NKM Fashion Limited

02 February 2025

2. Observation

Observation-1: Inconsistency in design report & material strength consideration. (Production Building)

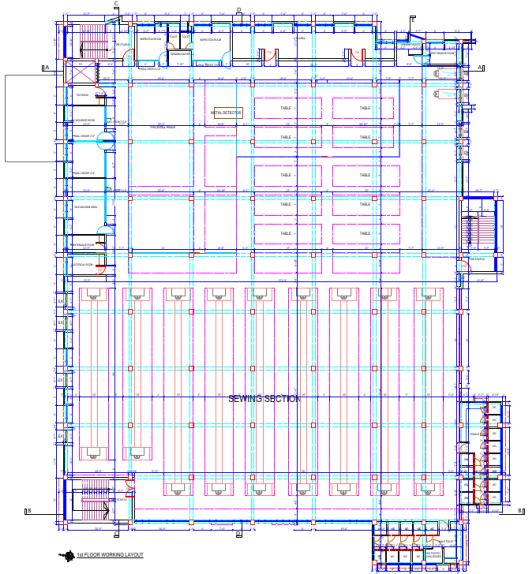
Description: Detailed Seismic load calculation and seismic detailing calculation are not addressed in the design report. The design concrete strength and frequency of testing, as per BNBC 5.12.1, are not discussed in the design report.

The building engineer is required to review the design report, including the material strength and prepare the design report as per BNBC 1.9.1.

Observation 2: Lack of information in as-built drawing. (Production Building)

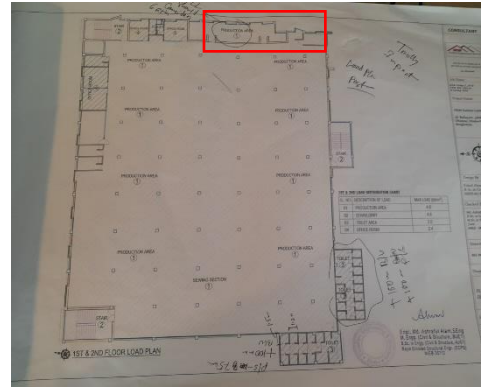
Description: Toiler build-ups and water Tanks are not shown in the as-built drawing. The building engineer is required to survey the structure and prepare accurate and detailed as-built drawings.

Observation-6: Damage of column due to trolley impact. (Production Building)

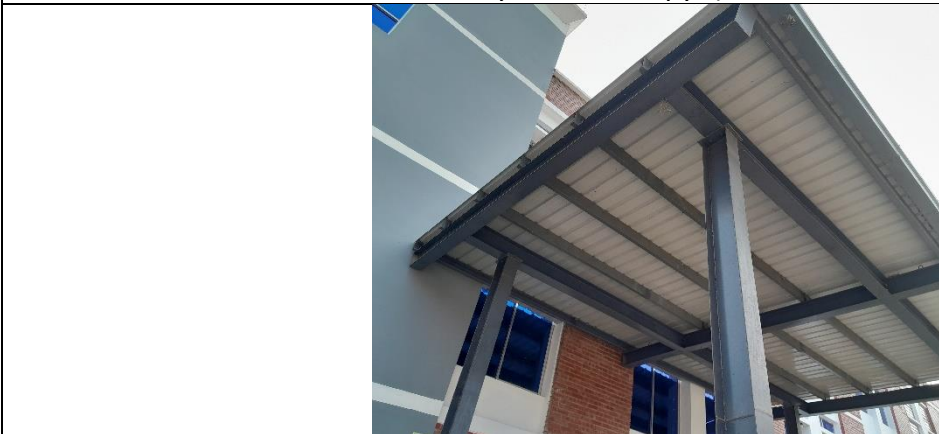
Description: Damage due to trolley impact was observed on the floor. The building engineer is required to repair the damage and provide trolley impact protection.

Observation 9: Lack of information in as-built drawing. (Admin Building)

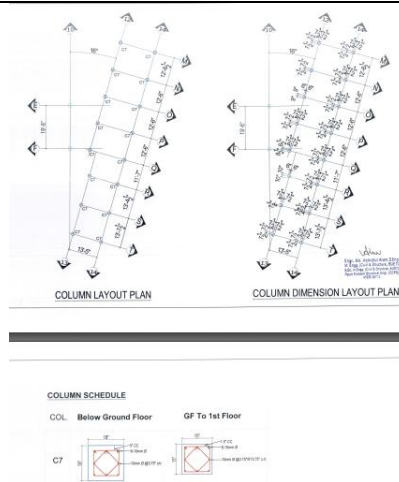
Description: The height of the FB-1 & FB-5 was found to be 18 inches instead of 20 inches. The building engineer is required to survey the structure & prepare accurate, detailed as-built drawings.

Observation 10: Slender column. (Utility Building)

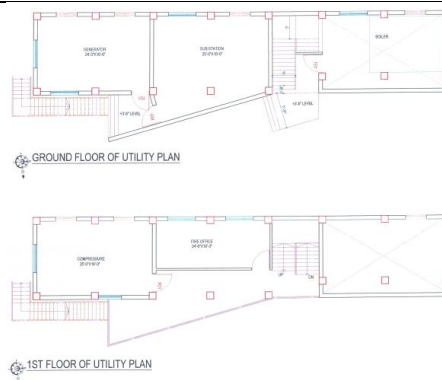
Description: The ground floor height is 5.25 m, and the column size is 375 mm X 375 mm. The building engineer is required to check the slenderness of the columns.
